PRODUCT/PROCESS CHANGE NOTIFICATION

Addendum1 – Packing Specification

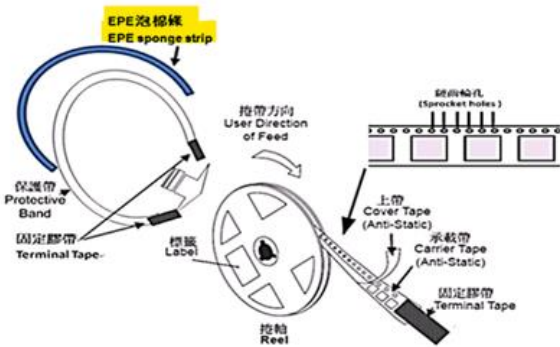
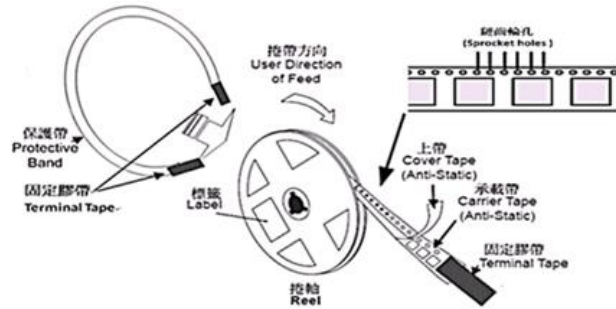
Remove strip foam and bubble sheet to optimize packing for sustainability
